DOE/OR/21548-135

Responsiveness Summary for the Remedial Investigation/Feasibility Study for Management of the Bulk Wastes at the Weldon Spring Quarry, Weldon Spring, Missouri

August 1990

U.S. Department of Energy
Oak Ridge Operations Office
Weldon Spring Site Remedial Action Project

Figure 9

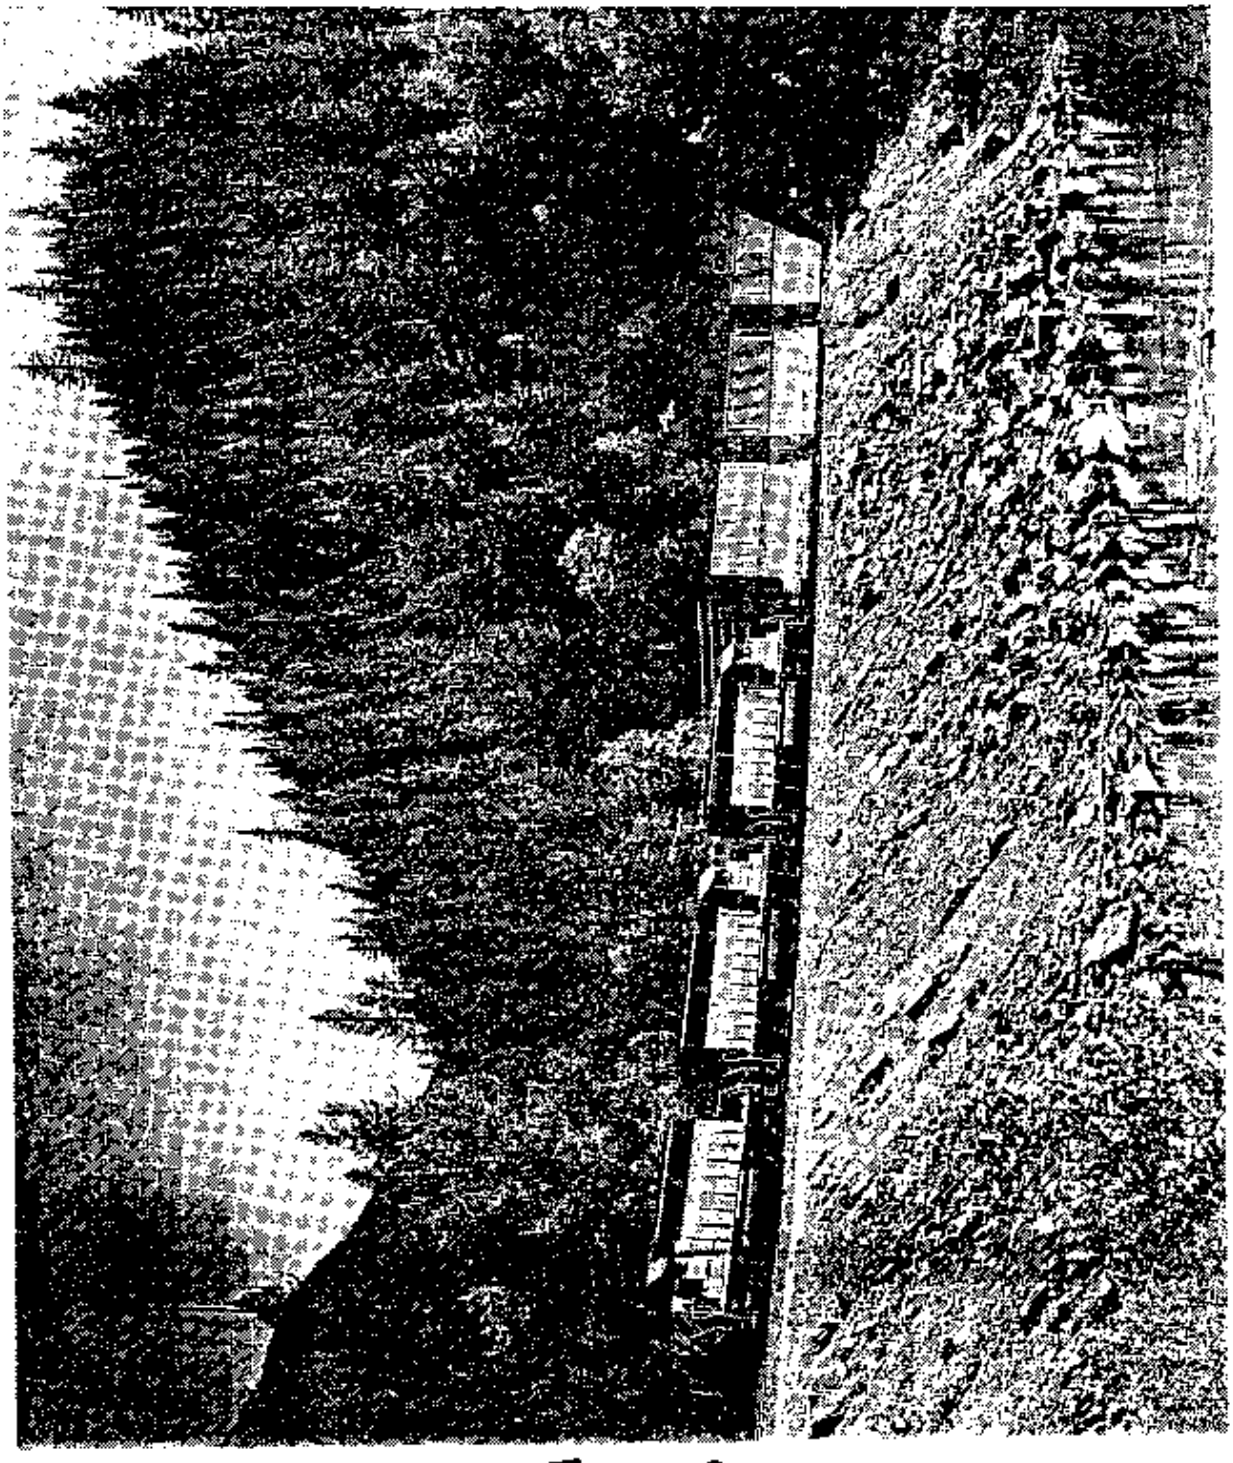
(5) reduces potential for driver error during hauling of waste materials (i.e. rail line itself acts as a guide mechanism to follow the haul route) (Figure 9 & Figure 10 Attached pages)

Railroad Spur: 4-7-90
Weldon Spring Quarry Site

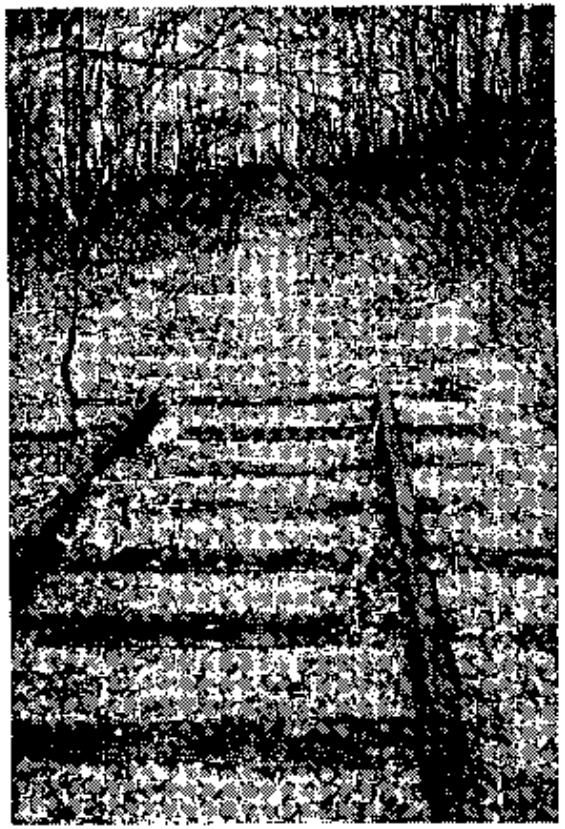
A) 50' rail & tie section missing south of first road crossing from Weldon Spring Chemical Plant

C) Bad switch at Water PLANT #1

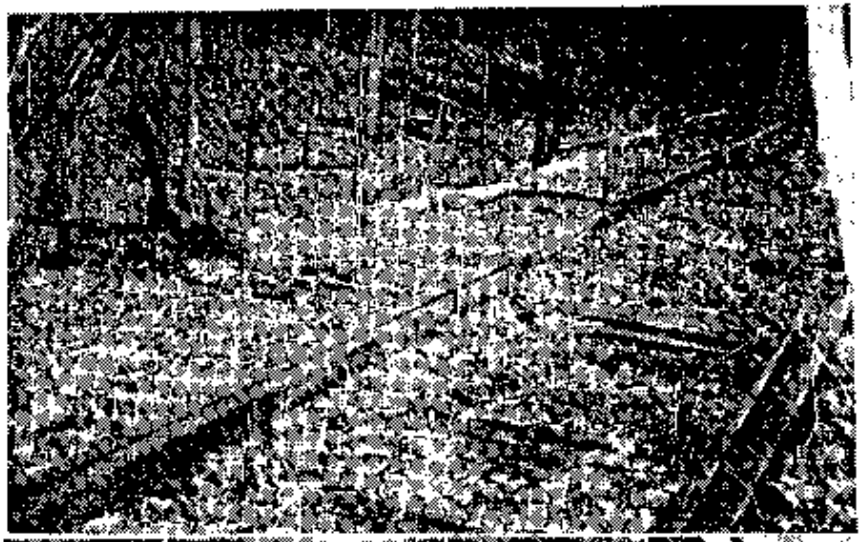
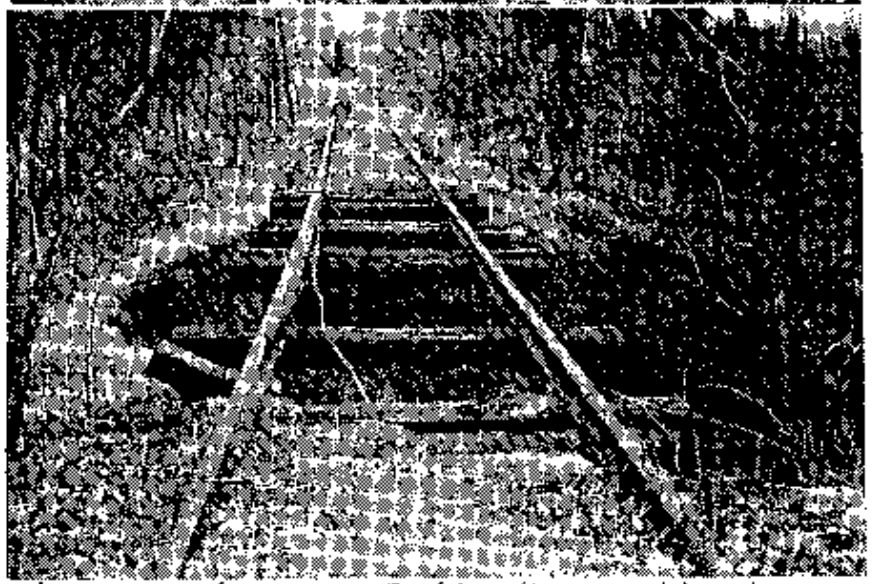
B) WASHOUT AREA 34' Length x 12' Depth North of ABANDONED WATER PLANT.

Railroad Spur: 4-7-90
Weldon Spring Quarry Site

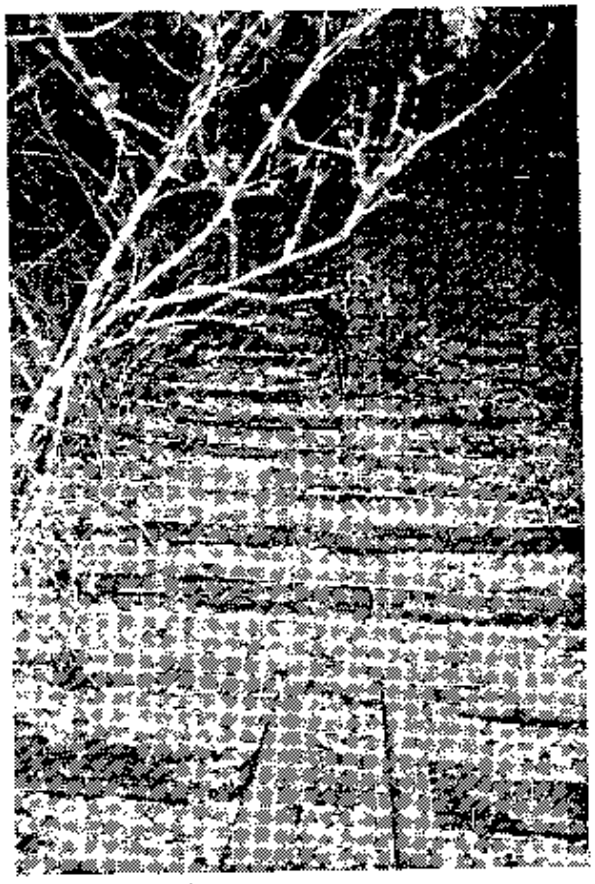
D.) Missing rail section, "FROG", NORTH of Quarry road crossing at Hwy 94 South

D) Missing switch NORTH of Quarry road crossing at Hwy 94 South

Railroad Spur: 4-7-90
Weldon Spring Quarry Site

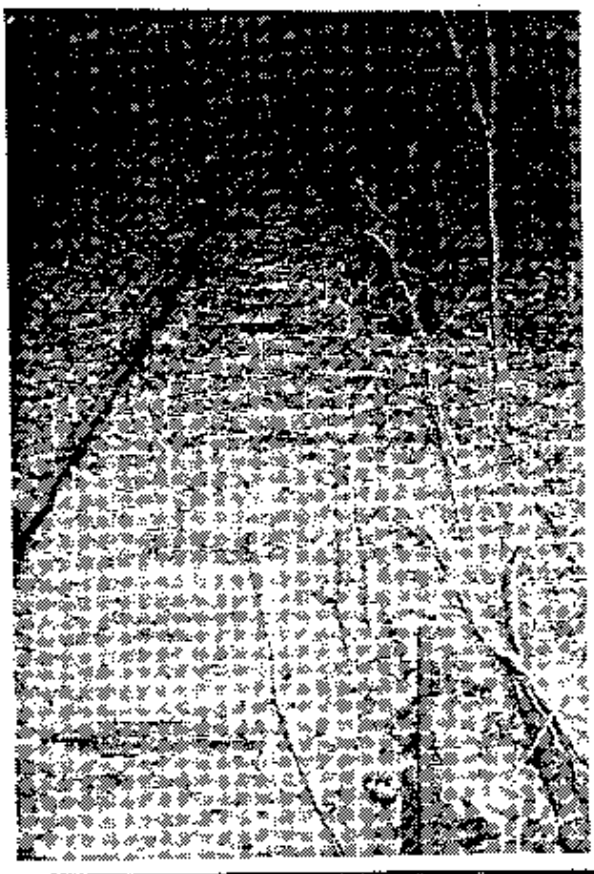
D) Missing rail section "FROG", South of Quarry road crossing at Hwy 94 South.

D) Missing Switch South of road Crossing at Hwy 94 S at Quarry.
